## WEST SUSSEX COUNTY COUNCIL CONSULTATION

<b>TO:</b>	Arun District Council FAO: Hannah Kersley
<b>FROM:</b>	WSCC – Highway Authority
<b>DATE:</b>	28 January 2026
<b>LOCATION:</b>	Phase 6a Hampton Park Littlehampton
<b>SUBJECT:</b>	LU/249/25/RES Approval of reserved matters following LU/47/11/ (amended by LU/182/15) comprising 288 No residential dwellings, the formation SUDs features, children's play space, landscaping, car parking, roads, landscaping and public access to the northern extent of the Black Ditch Open Space.
<b>DATE OF SITE VISIT:</b>	n/a (desktop study undertaken as site visited previously)
<b>RECOMMENDATION:</b>	More Information Required

**Figure 1 – Screenshot of sheet 3: Annotated to show hedgerows within areas likely to be offered for highway adoption and containing hedgerow planting (note the northern hedgerow is within the assumed indicative visibility splay shown). Hedgerow to be removed from the plans.**

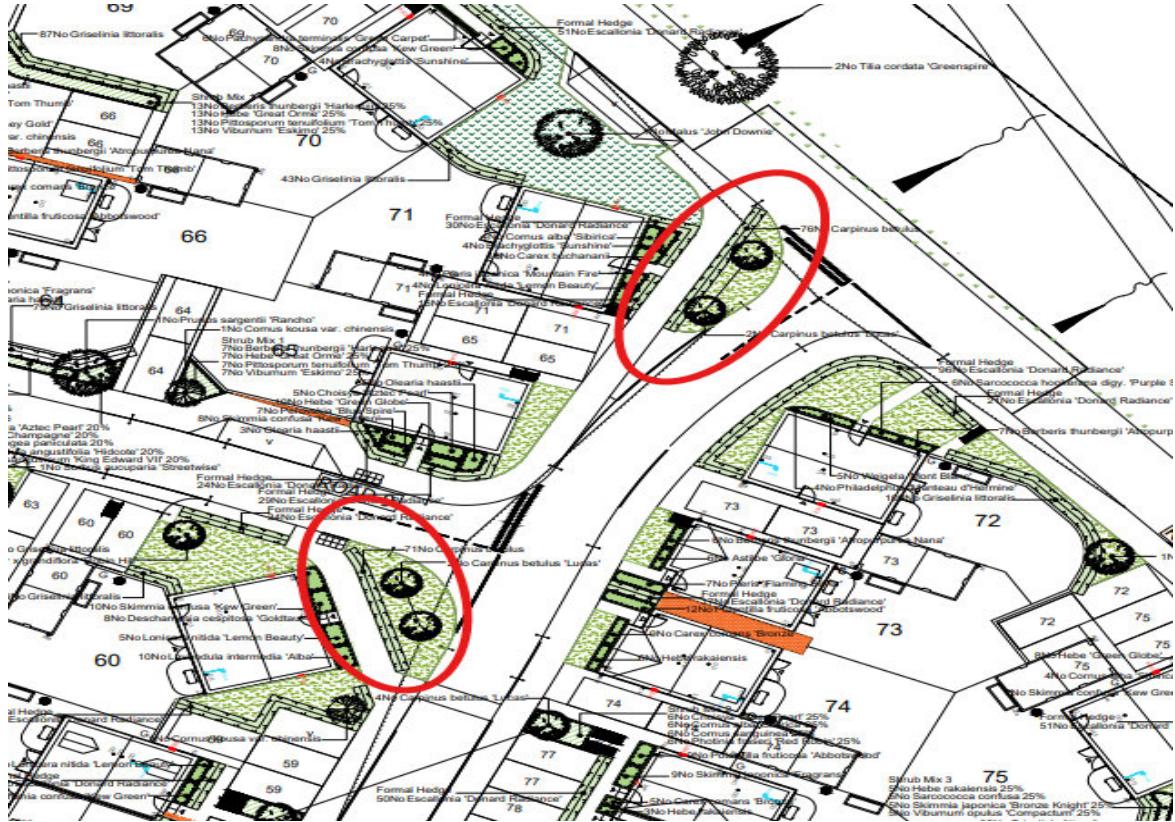
- Tree selection: *Malus 'John Downie'* should be avoided near to footways of carriageways which are to be proposed for highway adoption due to fruiting abundance and relating future nuisance concerns.
- Hedgerow planting will not be acceptable for highway adoption due to ongoing maintenance requirements (sheet 3, x2 locations).
- Planting should not obstruct forward visibility of junctions (sheet 3, x1 hedgerow).
